AGENDA
Regular Hybrid Meeting
Town of Granby
Inland Wetlands and Watercourses Commission
Wednesday, July 9, 2025, at 7:00 pm
Town Hall Meeting Room

This letter is being submitted by Kimley-Horn & Associates, Inc. on behalf of AutoZone, Inc. ("Applicant") in response to the department review letters listed below:

AUTOZONE GRANBY

8 E GRANBY ROAD
GRANBY, CT 06035

SHEET 1 OF 1
1

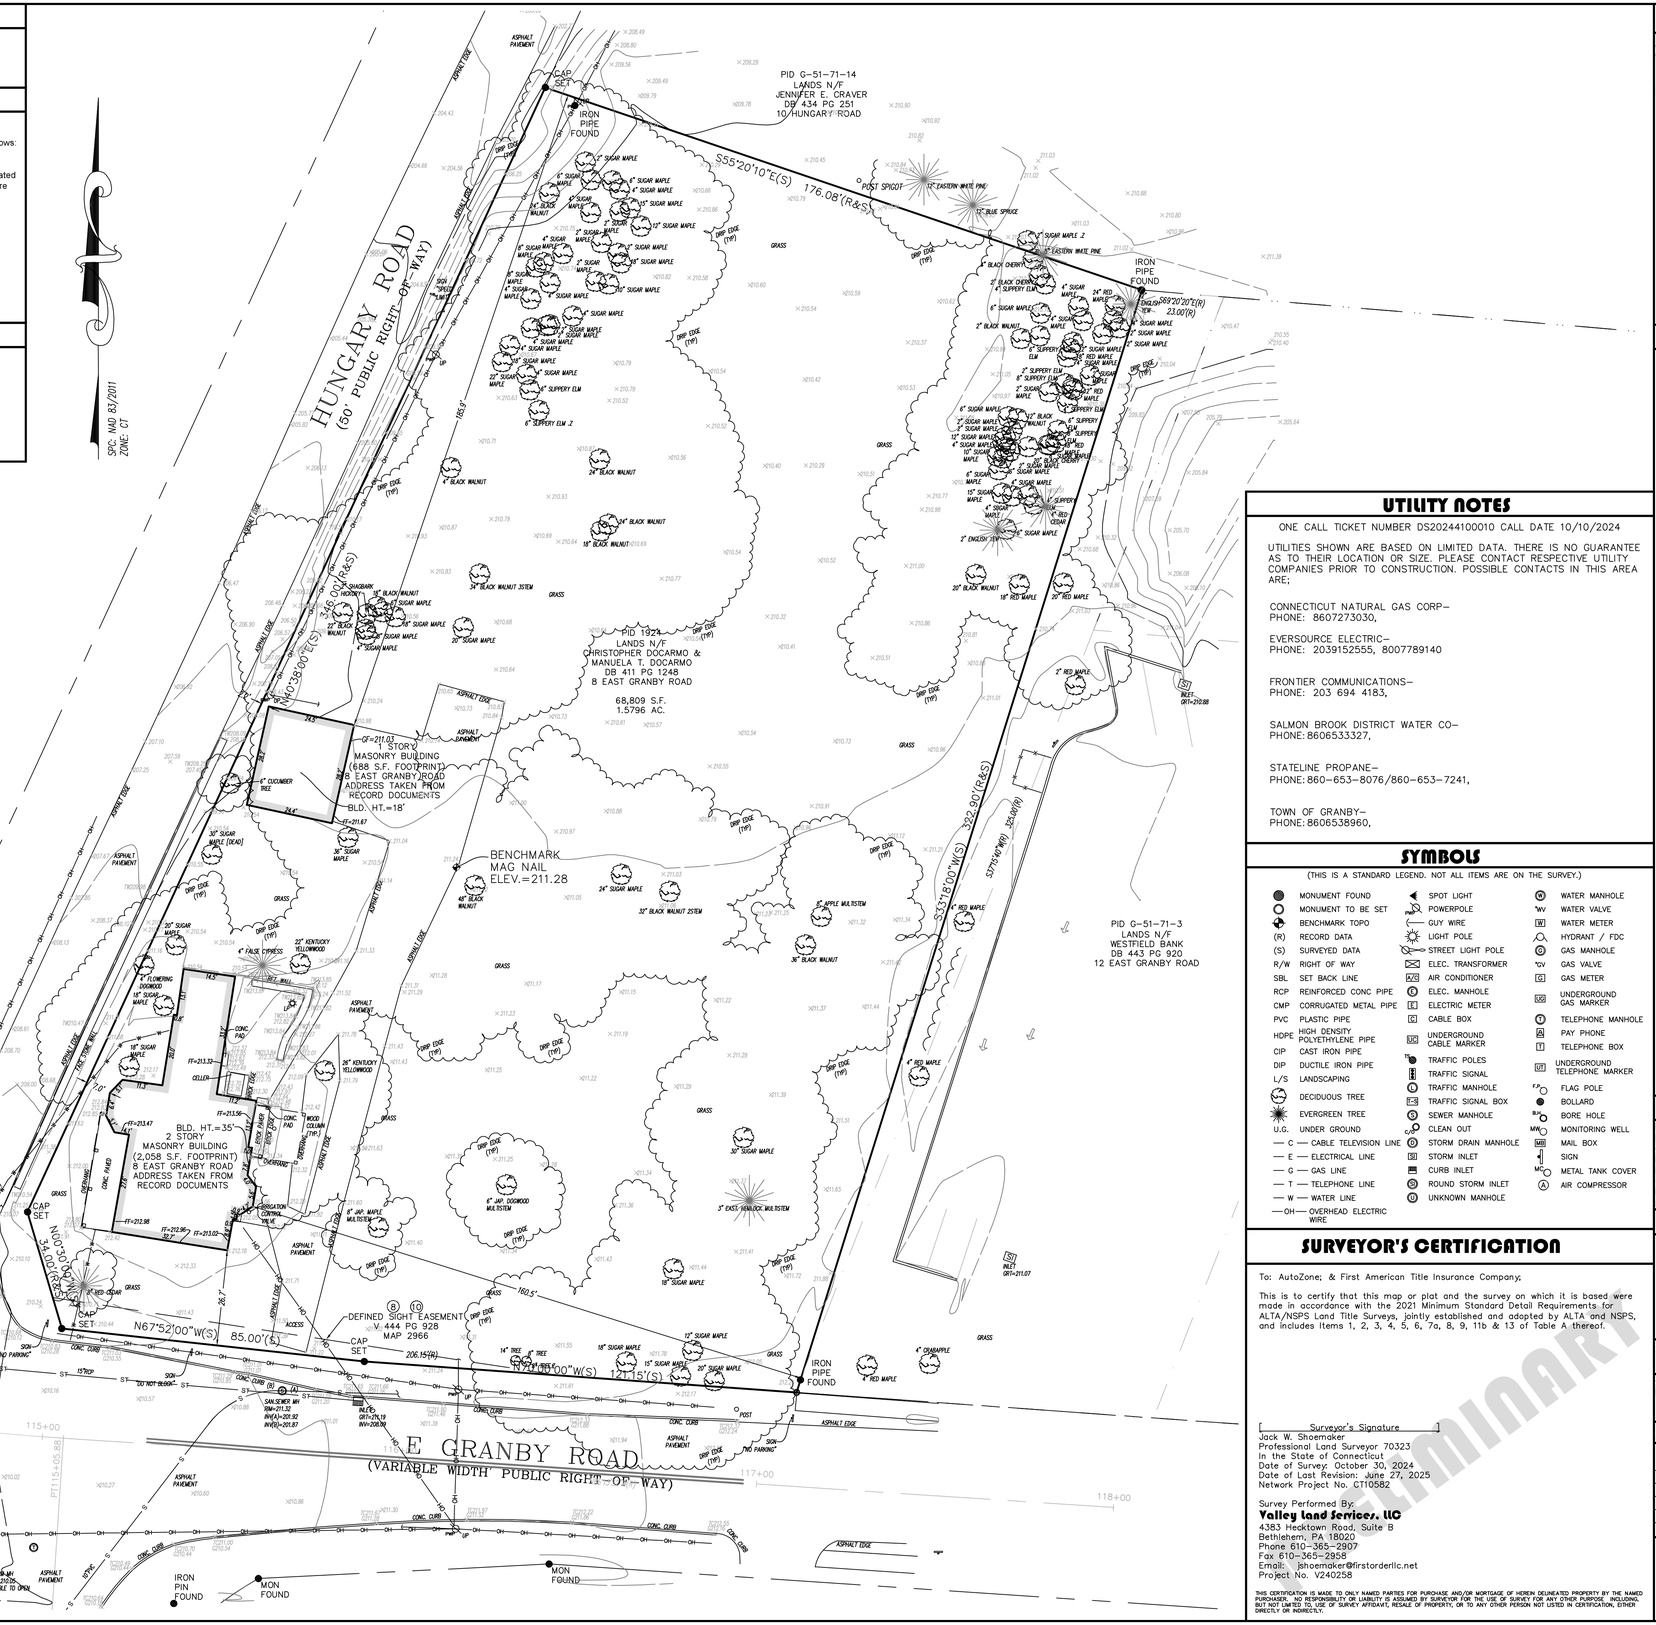
2. Show existing information easterly from site past the property line by about 20-feet.

3. For the trees to shown on the survey that are to remain, show their existing drip line.

5. The tree line shown on Sheet 1 of 1 the Site Survey and subsequent site plans shows the westerly tree line type indicating that the tree line is located to the east. It appears that this is intended to indicate that the tree line is located to the west, along Hungary Road. Please confirm.

Response: The survey has been revised to include the existing information east of the property approximately 20'.

Response: The survey has been revised to show all existing trees on the property and the existing drip line. The civil design sheets have been revised to show which trees are to remain and the remaining drip line.

Response: The survey has been revised to indicate the tree line along Hungary Road to be to the west. The civil plan set has been revised to match.

SHEET NUMBER
C-1.0

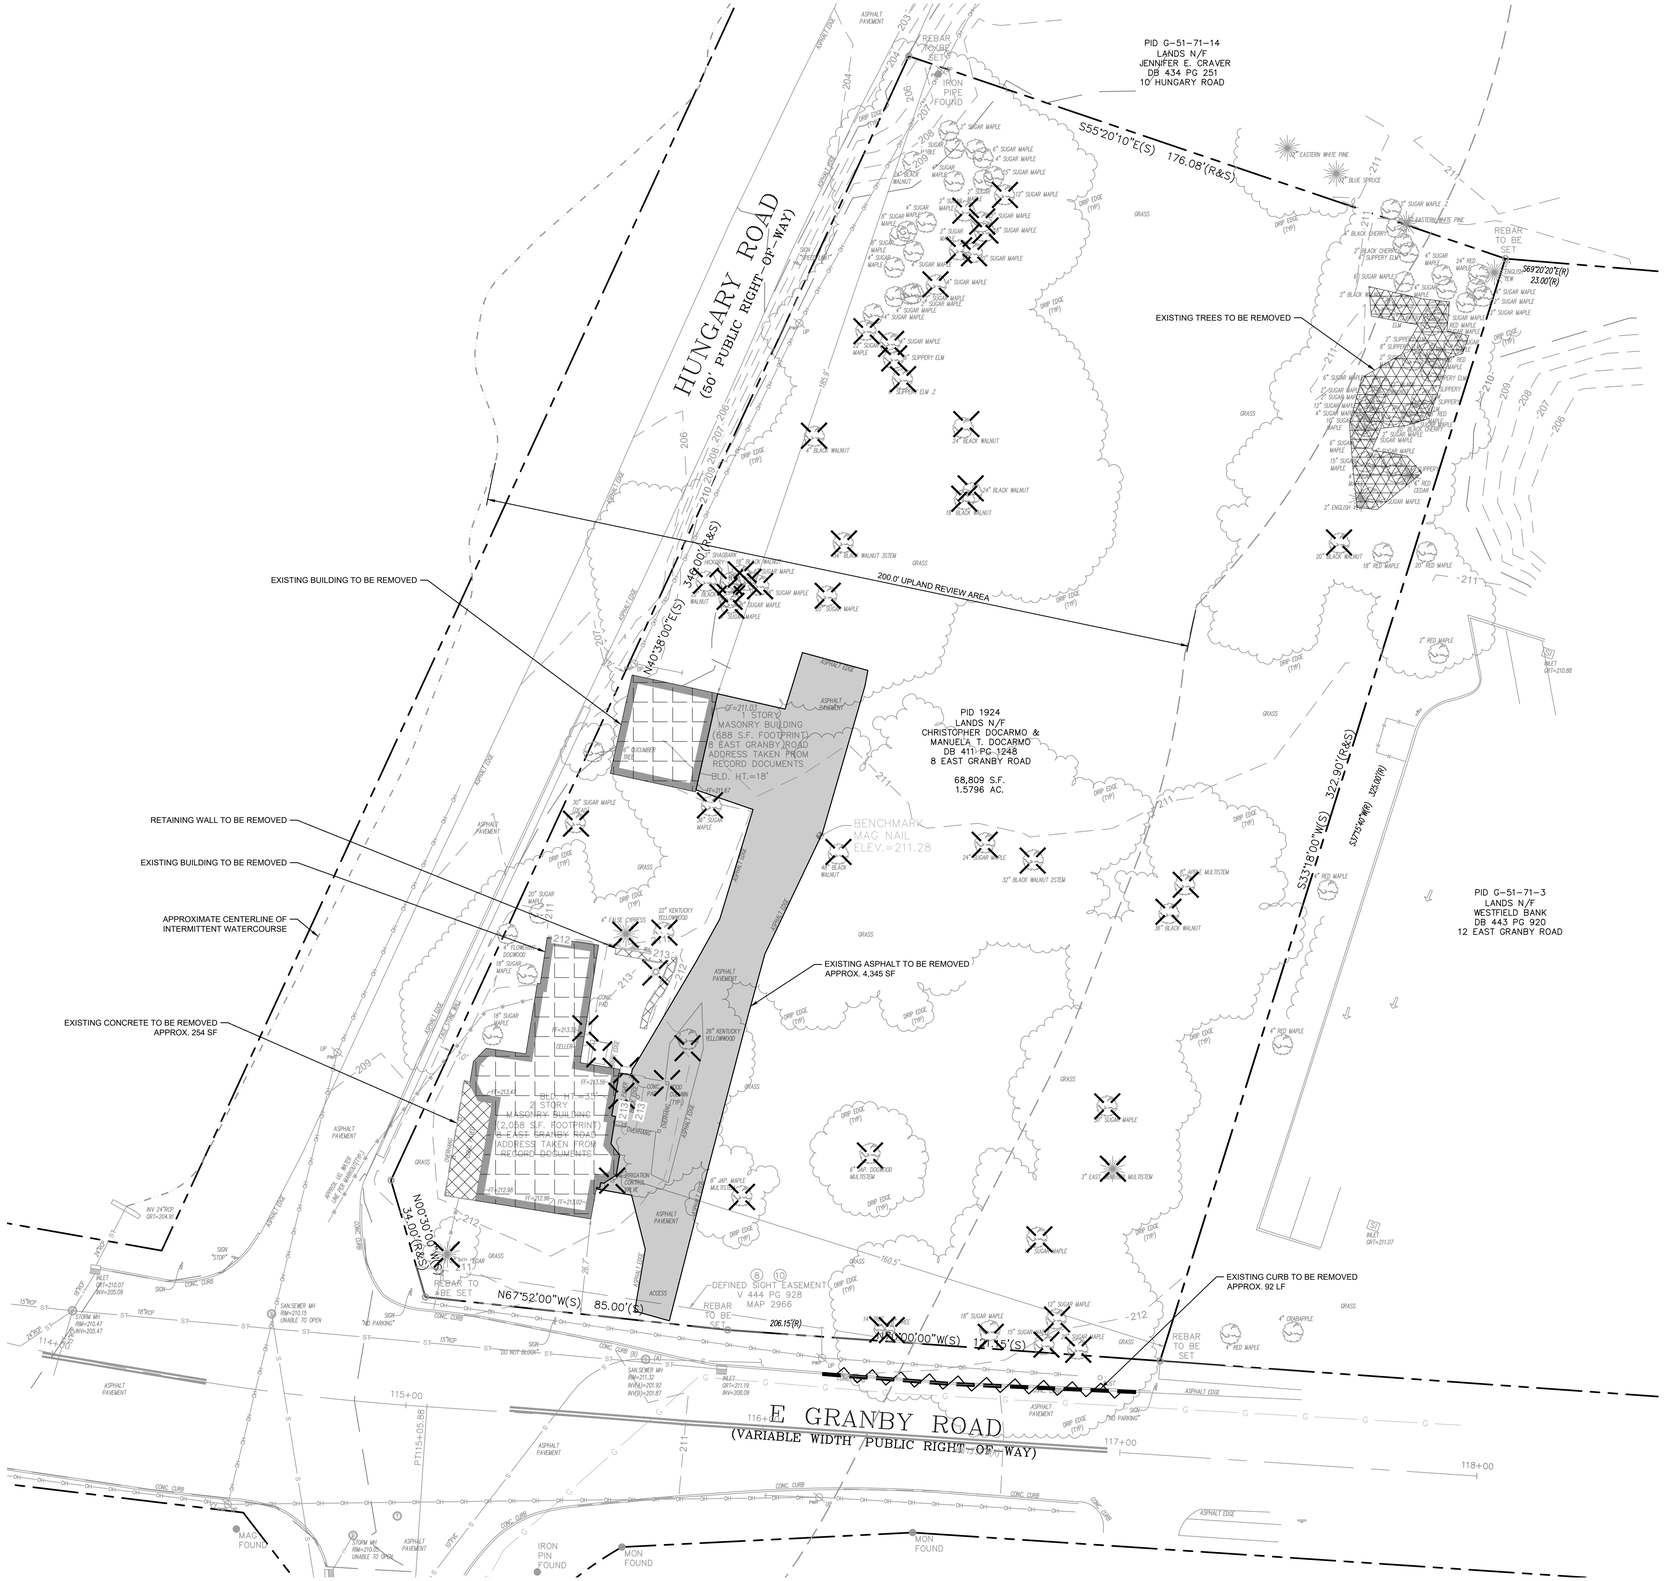
4. Please confirm and supply the reference to how the "Approximate Centerline of Intermittent Watercourse" shown on sheet C-1.0 has been determined.

Response: The centerline of the intermittent watercourse shown on Sheet C-1.0 was determined by as-builts provided by the Town of Granby and aerial imagery. Note 5 has been added to Sheet C-1.0 detailing the determination.

SHEET NUMBER
C-3.0

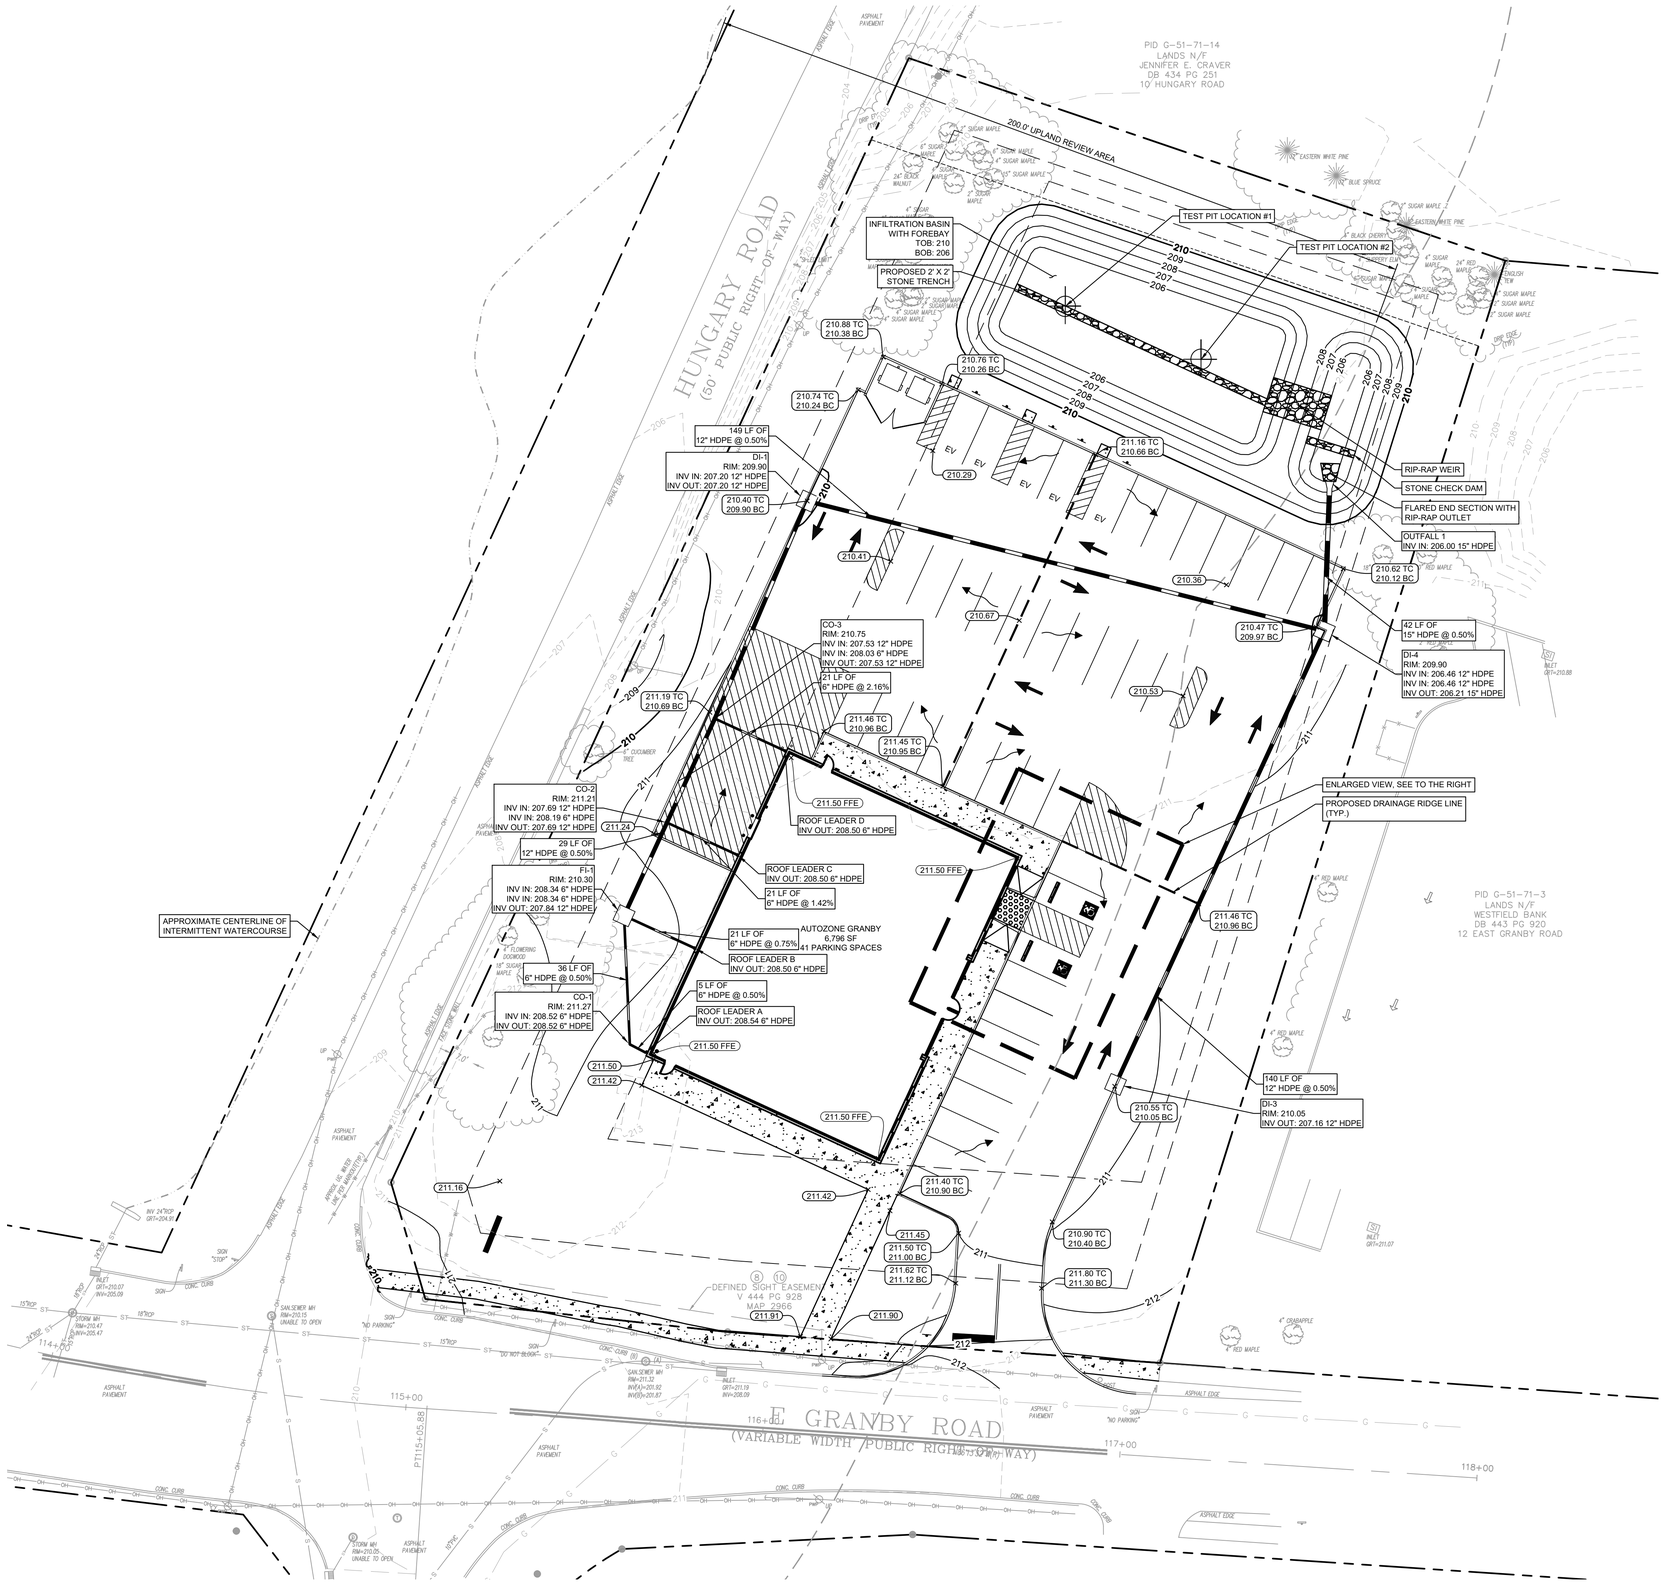
4. Add a stone trench at least 2-feet deep in the infiltration area to provide for infiltration during periods of frozen ground.

5. Show additional spot grades in the pavement areas to indicate how the pavement will drain.

17. At least two test pits are required in the proposed infiltration basin to support the design infiltration rate described on page 16 of the Stormwater Management Report. Add the test hole pit to the report and on sheet C-3.0. Test pits and soil data reporting to comply with the Connecticut Stormwater Quality Manual, March 30, 2024, Chapter 10, Test pits and Borings, pages 178 and 179. Refer design infiltration rate to table 10-2 and add it to the drainage report.

Response: The infiltration basin has been revised to include a 2' x 2' stone trench to promote infiltration during periods of frozen ground. A detail is of the stone trench is provided on Sheet C-6.1.

Response: Sheet C-3.0 has been revised to include additional spot grades, drainage ridge lines, and drainage flow lines to denote the drainage within the pavement area.

Response: Comment Acknowledged. Infiltration basin construction notes have been included on Sheet C-3.0.

Response: Two test pits were completed on 6/24/25. The results have been added to the stormwater report and the locations are shown on C-3.0. An infiltration rate of 26 in/hr was observed, therefore, a design rate of 13 in/hr is utilized for the design calculations.

SHEET NUMBER
C-4.0

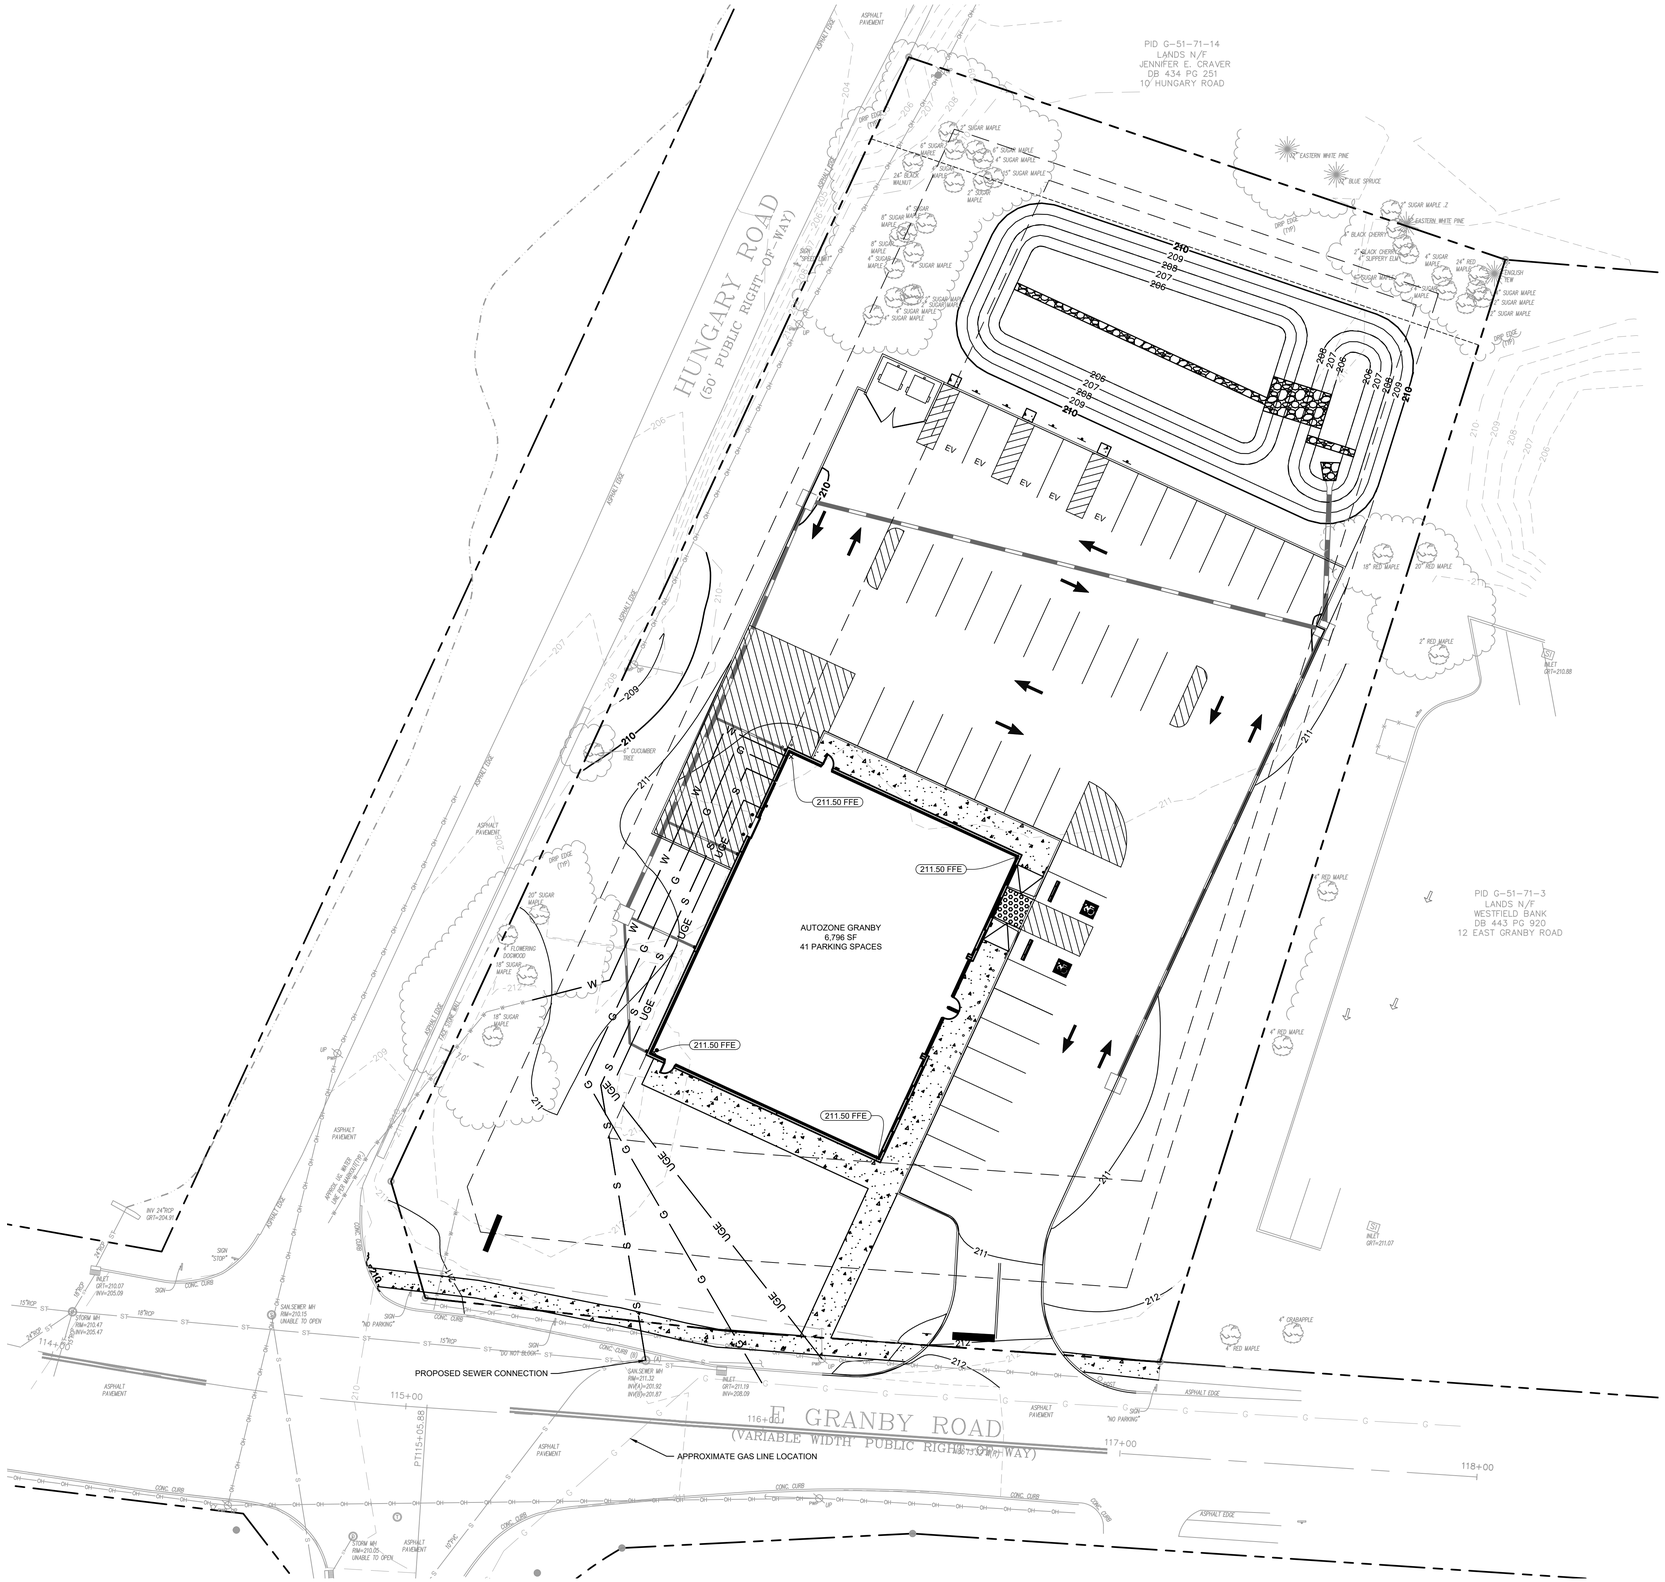
6. Show FFE.

7. Additional information (e.g. inverts, cleanouts, pipe length and slope, etc.) is required for the sanitary sewer connection. This is not needed for the wetlands application but will need to be shown on the site plan application plans.

Response: Sheet C-4.0 has been revised to include the FFE.

Response: Comment Acknowledged. Additional information regarding the sanitary sewer connection will be provided with the site plan application plans.
